Moa Point Wastewater Treatment Plant

flood incident: Independent review

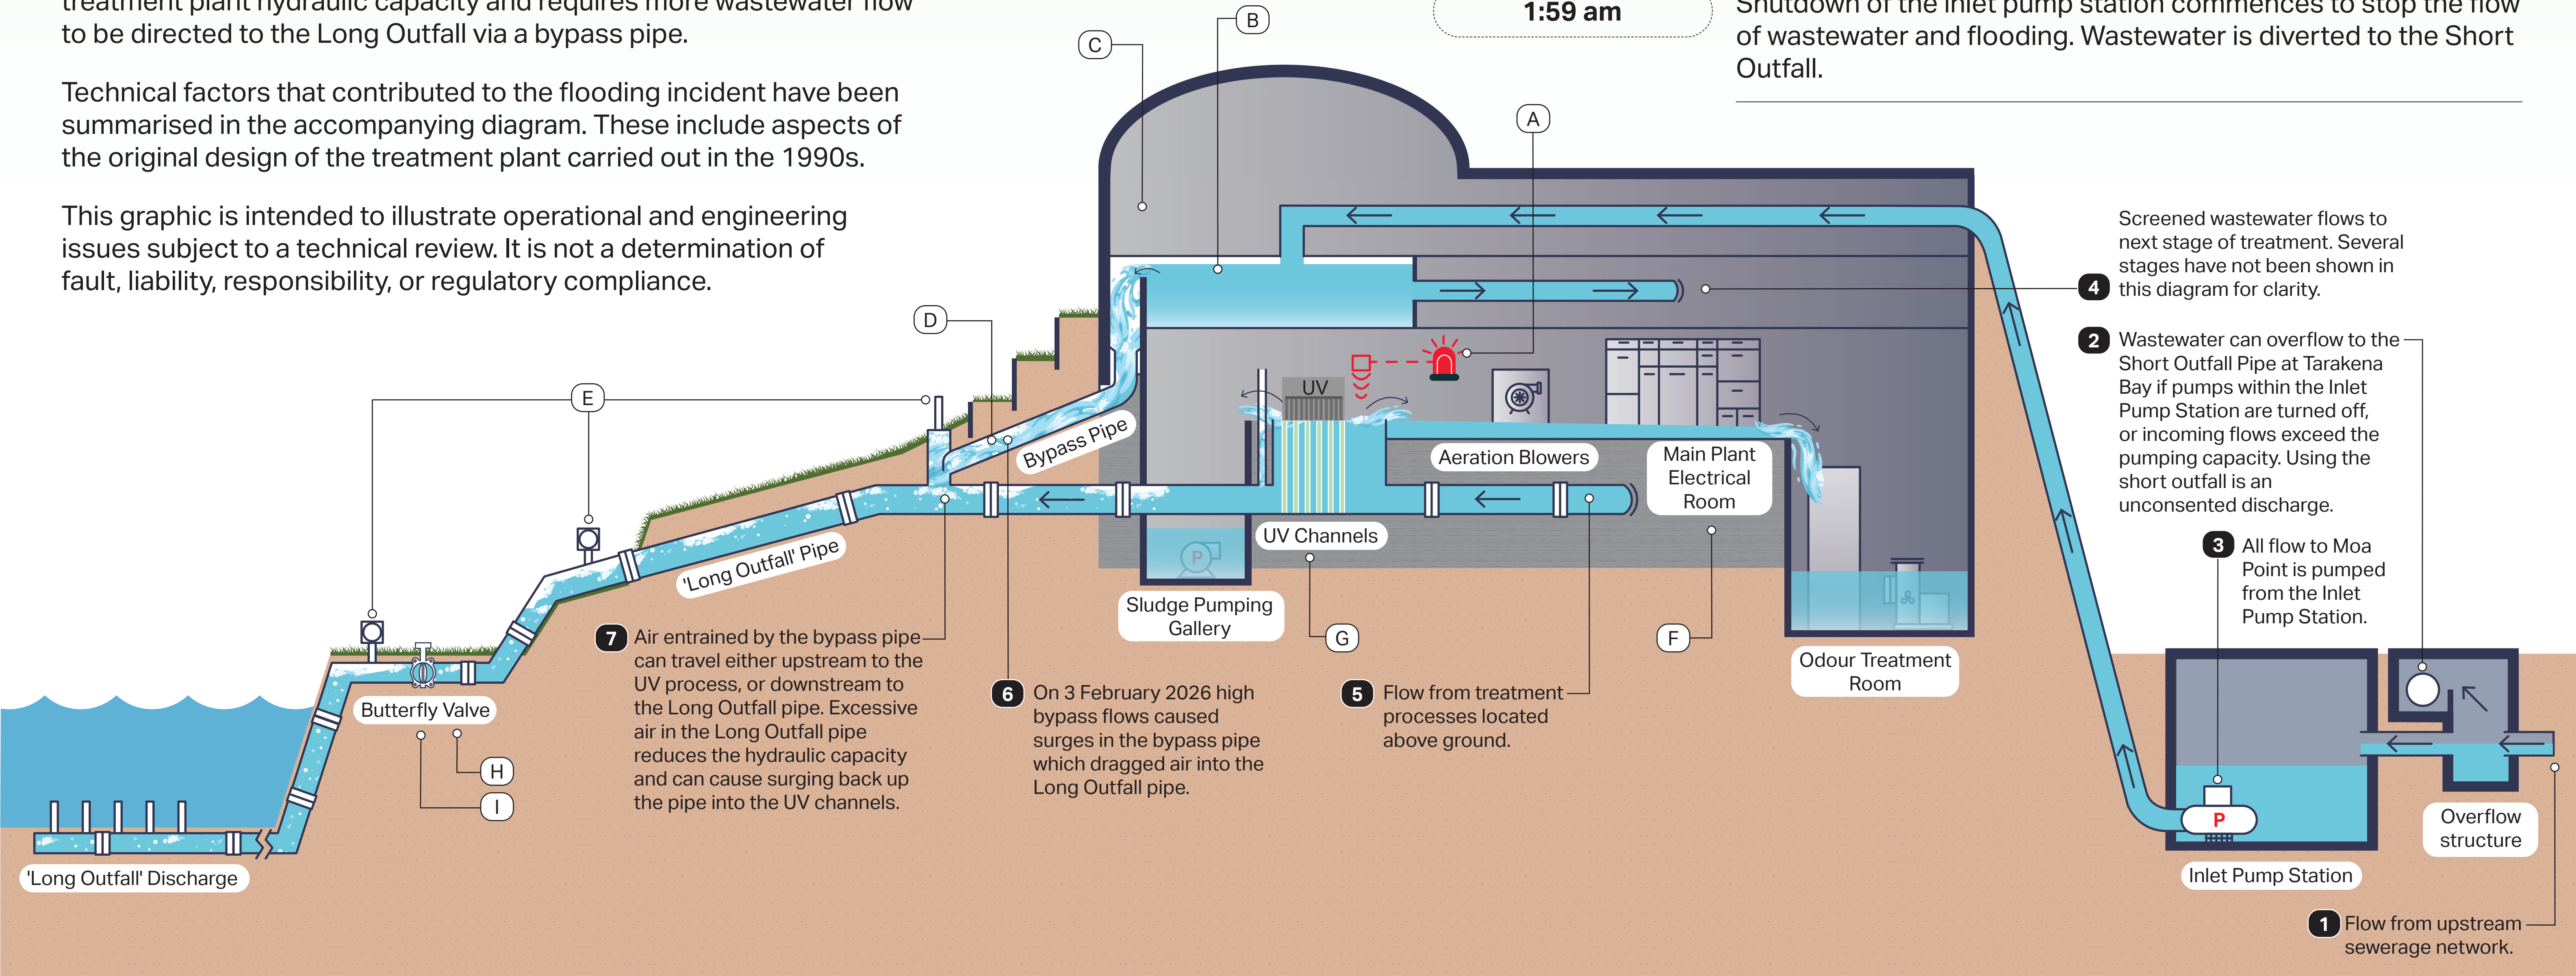
| <p>A Design documentation reviewed from the original 1990s design did not include or infer any need for level sensors with high level alarms to alert staff to high water levels in the UV room, or to stop flow from the Inlet Pump Station.</p> | <p>D The original 1990s design implies that the bypass pipe is intended to handle 4,000 litres per second of flow. Hydraulic calculations reviewed from the original 1990s design do not appear to consider the combined, bypass pipe, Long Outfall and wastewater treatment plant system. They also do not appear to test the scenario where 4,000 litres per second is directed through the bypass pipe.</p> | <p>G Early design concepts for the wastewater treatment plant included four UV channels. Between these early concepts and the 1994-96 design, the number of UV channels was reduced two. Documentation reviewed from the 1994-96 design indicates that the intent was to increase the capacity of the UV process by making structural changes to the two UV channels and modifications to UV equipment, when required in the future. However, the documentation does not describe how this was to occur without a reduction in UV hydraulic capacity, which would lead to increased flows being directed to the bypass pipe. This meant a redundant UV channel was not available to maintain hydraulic and treatment capacity during the eventual replacement of UV equipment in 2026.</p> |
| <p>B Design documentation reviewed from the original 1990s design indicates the treatment process was designed for 3,000 litres per second of flow, the Inlet Pump Station was designed for 4,000 litres per second of flow, the bypass pipe is intended to handle 4,000 litres per second of flow and the Long Outfall pipe was designed to handle 4,500 litres per second of flow. During the flooding incident the bypass flow did not exceed 2,300 litres per second.</p> | <p>E Air relief valves and vents along the Long Outfall pipe, while consistent with the original design, may not be of an appropriate size or type and may not have released air fast enough. This is currently under investigation. The purpose of the air relief valves is to release air from the Long Outfall pipe, so the air does not restrict the flow of the wastewater.</p> | <p>H Potential downstream obstructions may have contributed to the flooding incident. These are currently under investigation.</p> |
| <p>C Design documentation reviewed from the original 1990s design did not identify the risk of surges and/or air entrainment in the bypass pipe. Air entrainment is a process where air is mixed with a liquid (e.g., wastewater). It occupies pipe volume and can restrict the flow of wastewater in a pipe.</p> | <p>F The original design and construction in the 1990s placed critical infrastructure (such as the main plant electrical room), below ground and within overflow pathways without flood protection barriers, suggesting that the risk of flooding to lower levels of the plant was considered to be low during the design process or due to the physical constraints of the site.</p> | |
